Access Compliance Report

Public Rights-of-Way

Intersection ID: 10589	Main Street: N_GRAHAM_ST	Cross Street: ARMOUR_DR	Location:	W
ADA ID: 926857F59A8B	Ramp Type: PerpDiag	Initial Pass/Fail: Fail	Overall Compliance: No	Severity Score: 25

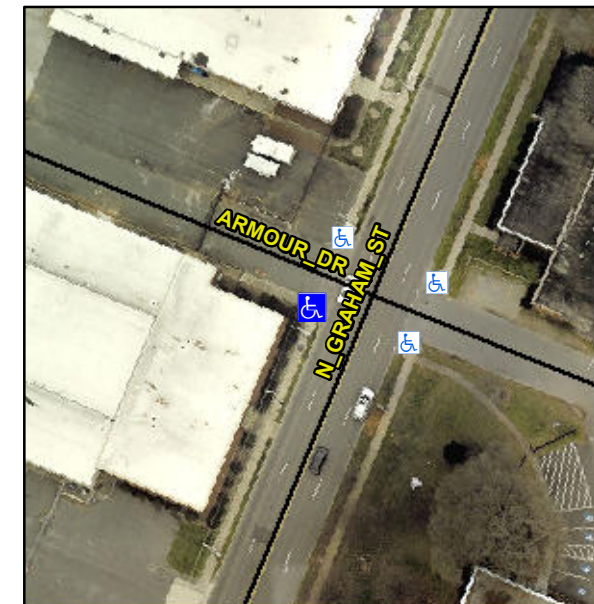
Not Found, R304.2.2

Compliance	Description	Data	Compliance	Description	Data
N/A	Ramp Length (in)	38.0	No	Ramp Slope (%)	16.1
Yes	Ramp Width (in)	48.0	Yes	Ramp XSlope (%)	1.5
N/A	Flare Type LT	N/A	N/A	Flare Type RT	N/A
N/A	Flare Slope LT (%)	N/A	N/A	Flare Slope RT (%)	N/A
N/A	Flare Traversable LT?	N/A	N/A	Flare Traversable RT?	N/A
N/A	Landing Length (in)	N/A	N/A	DWS Provided?	N/A
N/A	Landing Width (in)	N/A	N/A	DWS Contrast?	N/A
N/A	Landing Slope (%)	N/A	N/A	DWS Length (in)	N/A
N/A	Landing X Slope (%)	N/A	N/A	DWS Full Width?	N/A
N/A	Landing Curb? (Y/N)	N/A	N/A	DWS Offset (in)	N/A
N/A	Shared Landing?	N/A			
N/A	Gutter Ponding?	N/A	N/A	Gutter Slope (%)	N/A
N/A	Gutter Lip Ht (in)	N/A	N/A	Gutter X Slope (%)	N/A
N/A	Painted X Walk1?	No	N/A	Painted X Walk2?	No
	X Walk 1 Direction	To SE		X Walk 2 Direction	To NE
N/A	X Walk 1 Width (in)	N/A	N/A	X Walk 2 Width (in)	N/A
	X Walk 1 Slope (%)	3.3		X Walk 2 Slope (%)	1.2
	X Walk 1 X Slope (%)	1.5		X Walk 2 X Slope (%)	4.3

Remove & Replace Curb Ramp With Two New Directional Ramps or Equivalent.
